Access Compliance Report

Public Rights-of-Way

(Curb Ramps)

Intersection ID: 15363	Main Street: CUMBERLAND_AV	Cross Street: EAST_BV	Location: W
ADA ID: 1D4C3A94D7DC	Ramp Type: PerpDiag	Initial Pass/Fail: Fail	Overall Compliance: No
		Severity Score: 12.5

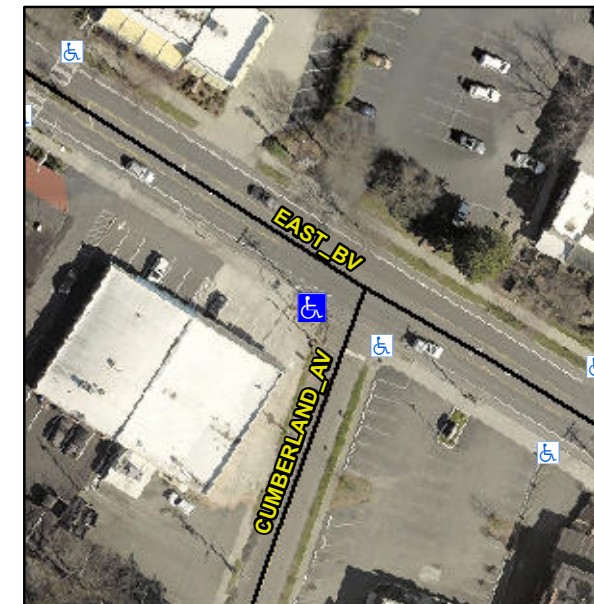
Not Found, R304.2.2

Compliance	Description	Data	Compliance	Description	Data
N/A	Ramp Length (in)	46.0	No	Ramp Slope (%)	11.1
Yes	Ramp Width (in)	48.0	Yes	Ramp XSlope (%)	1.8
N/A	Flare Type LT	N/A	N/A	Flare Type RT	N/A
N/A	Flare Slope LT (%)	N/A	N/A	Flare Slope RT (%)	N/A
N/A	Flare Traversable LT?	N/A	N/A	Flare Traversable RT?	N/A
N/A	Landing Length (in)	N/A	N/A	DWS Provided?	N/A
N/A	Landing Width (in)	N/A	N/A	DWS Contrast?	N/A
N/A	Landing Slope (%)	N/A	N/A	DWS Length (in)	N/A
N/A	Landing X Slope (%)	N/A	N/A	DWS Full Width?	N/A
N/A	Landing Curb? (Y/N)	N/A	N/A	DWS Offset (in)	N/A
N/A	Shared Landing?	N/A			
N/A	Gutter Ponding?	N/A	N/A	Gutter Slope (%)	N/A
N/A	Gutter Lip Ht (in)	N/A	N/A	Gutter X Slope (%)	N/A
N/A	Painted X Walk1?	No	N/A	Painted X Walk2?	No
	X Walk 1 Direction	To SE		X Walk 2 Direction	To NE
N/A	X Walk 1 Width (in)	N/A	N/A	X Walk 2 Width (in)	N/A
	X Walk 1 Slope (%)	3.7		X Walk 2 Slope (%)	4.9
	X Walk 1 X Slope (%)	3.3		X Walk 2 X Slope (%)	0.7

Remove & Replace Curb Ramp With Two New Directional Ramps or Equivalent.
